**Amendments to the Drawings:**

Fig. 13

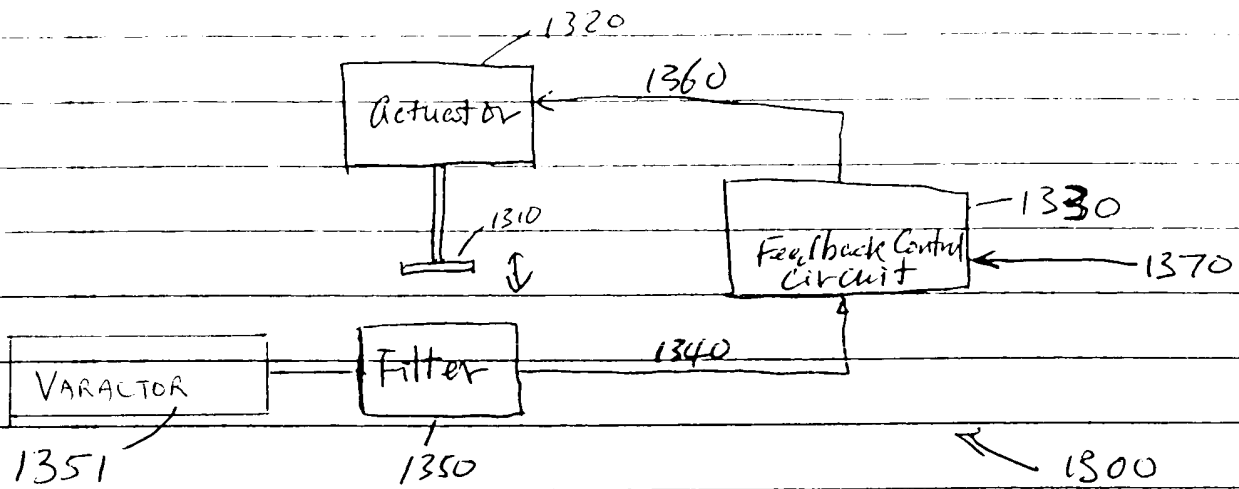
Fig. 13 has been amended. Fig. 13 now includes a functional block labeled varactor and identified by designation 1351.
